## SERVICE INSTRUCTION

# Running modifications of the Bing constant depression carburetor for ROTAX® Engine Type 912 and 914 (Series) and 582 UL mod. 99/mod. 17 (Series)

Running modifications of the Bing constant depression carburetor for ROTAX® Engine Type 912 and 914 (Series) and 582 UL mod. 99/mod. 17 (Series).

Fig. 1  
Throttle valve levers OLD and NEW

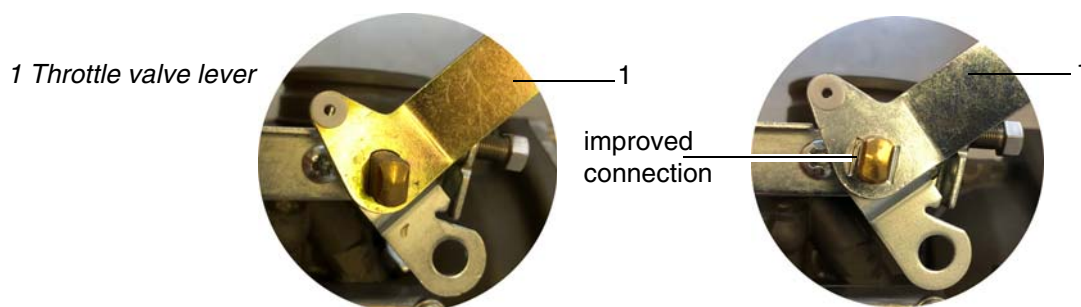
Throttle valve levers (1) were changed to a pressed notch style which provides improved connection to the throttle valve shaft. For the revised throttle levers part no. 963026 for the 1/3 carburetor and part no. 963021 for the 2/4 carburetor.

New throttle valve levers have been introduced as of:

Carburetor part no. 892500	from S/N 171420 inclusive
Carburetor part no. 892505	from S/N 171421 inclusive
Carburetor part no. 892520	from S/N 171517 inclusive
Carburetor part no. 892525	from S/N 171501 inclusive
Carburetor part no. 892530	from S/N 171748 inclusive
Carburetor part no. 892535	from S/N 171679 inclusive

Fig. 2  
Float chamber pins

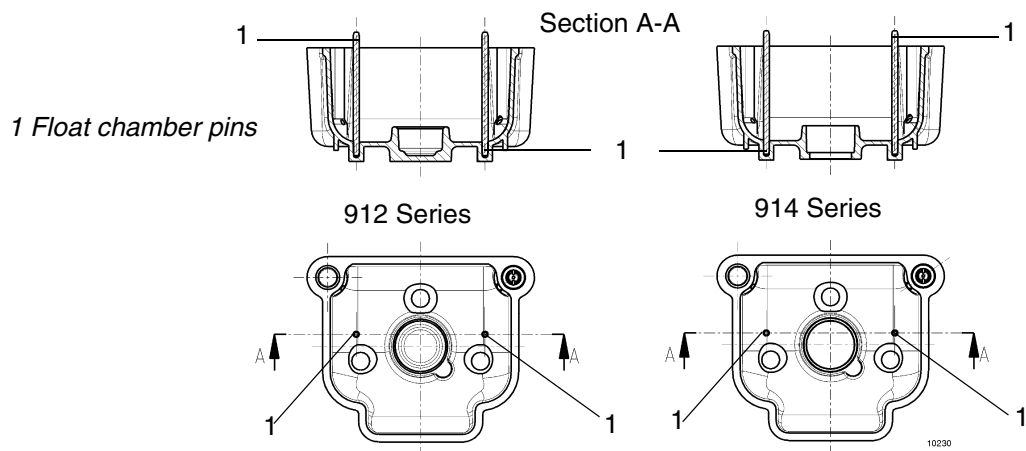
The installation of the float chamber pins (1) was changed to a blind hole in the float chamber bottom instead of a through bore. The float pins are now approximately 2 mm (0.078 in.) longer. Part numbers for the revised float chambers are listed in section 2.4 of this Service Instruction. New float chamber assemblies have been introduced as of:

Carburetor part no. 892500	from S/N 171420 inclusive
Carburetor part no. 892505	from S/N 171421 inclusive
Carburetor part no. 892520	from S/N 171517 inclusive
Carburetor part no. 892525	from S/N 171501 inclusive
Carburetor part no. 892530	from S/N 171748 inclusive
Carburetor part no. 892535	from S/N 171679 inclusive

*Fig. 3*  
*Throttle valve OLD and NEW*

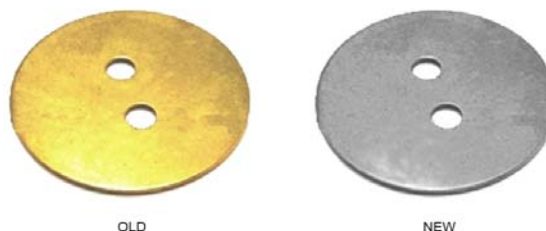
The throttle valve was changed to a machining process instead of die cutting process. The part number for the throttle valve is 963666.

New throttle valve has been introduced as of:

Carburetor part no. 892500	from S/N 171420 inclusive
Carburetor part no. 892505	from S/N 171421 inclusive
Carburetor part no. 892520	from S/N 171517 inclusive
Carburetor part no. 892525	from S/N 171501 inclusive
Carburetor part no. 892530	from S/N 171748 inclusive
Carburetor part no. 892535	from S/N 171679 inclusive

Fig. 4  
Floats OLD and NEW

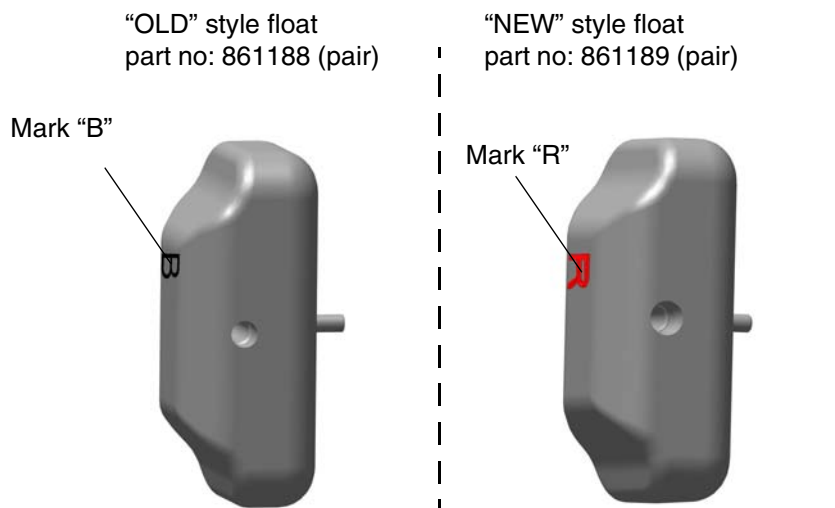
As per Maintenance Manual Line (MML) let the floats dry for 1-2 minutes. Only weigh dry floats. In no case the max. weight (of both floats together) is allowed to exceed 7 grams (0.0154 lb.). This applies to all floats, old and new.

The new floats are not marked with any identification “dots”, but have instead of the “B” an “R” as an identification mark.

New floats pair part no. 861189 has been introduced as of:

Carburetor part no. 892500	from S/N 185575 inclusive
Carburetor part no. 892505	from S/N 185690 inclusive
Carburetor part no. 892520	from S/N 185475 inclusive
Carburetor part no. 892525	from S/N 185630 inclusive
Carburetor part no. 892530	from S/N 185425 inclusive
Carburetor part no. 892535	from S/N 185326 inclusive

Fig. 5  
Carburetor parts

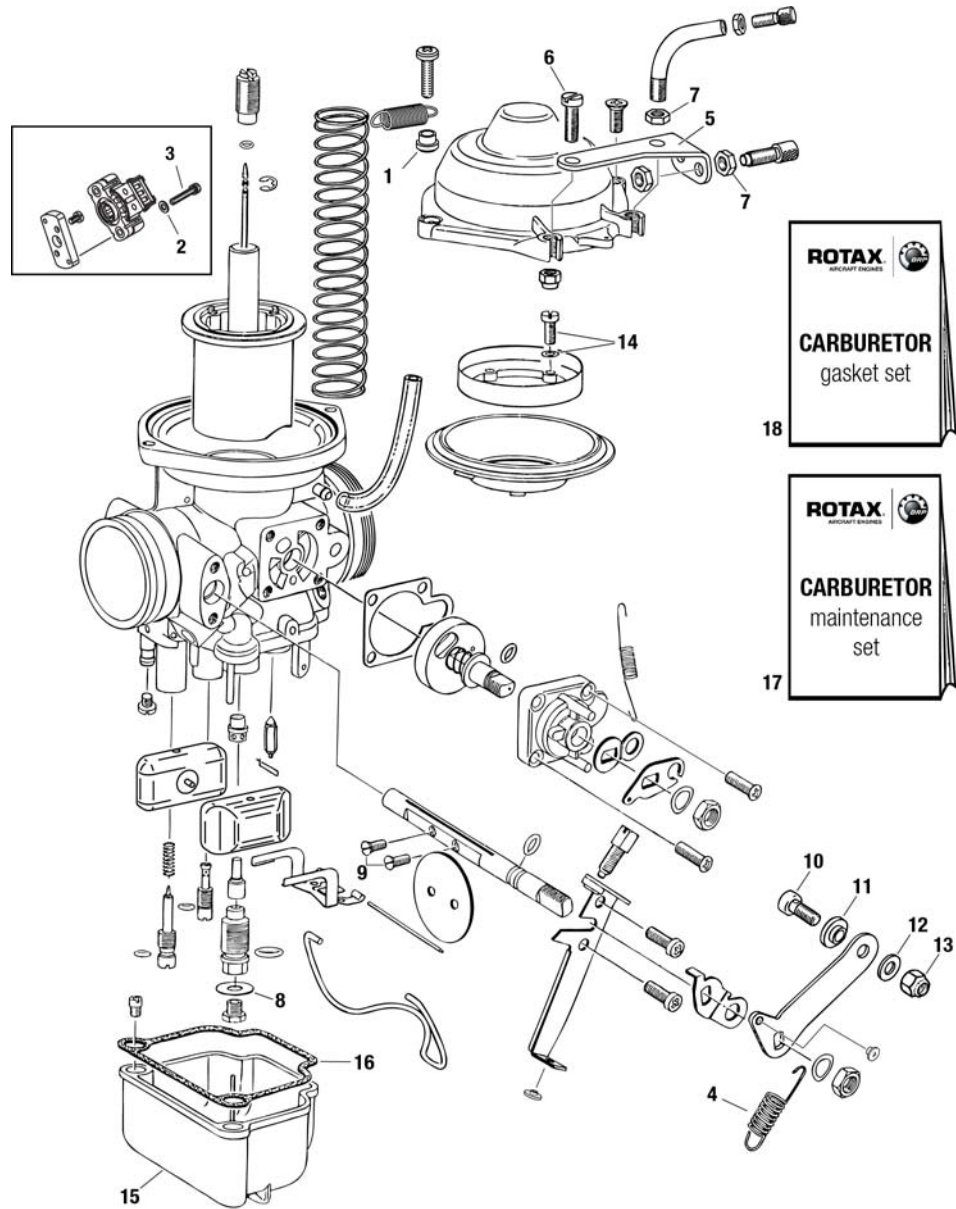
NOTE: Due to changing regulations all individual parts listed below are now free of CR6+ chromium.

The material of the float chamber (item no. 15) gasket (item no. 16) was changed to a Viton based material with new part no. 830721. This new gasket can be used instead of previous paper or cork gaskets part no. 830720 / 830724 / 830728.

New Viton gaskets have been introduced as of:

Carburetor part no. 892500	from S/N 172977 inclusive
Carburetor part no. 892505	from S/N 172883 inclusive
Carburetor part no. 892520	from S/N 172340 inclusive
Carburetor part no. 892525	from S/N 172450 inclusive
Carburetor part no. 892530	from S/N 172633 inclusive
Carburetor part no. 892535	from S/N 172783 inclusive
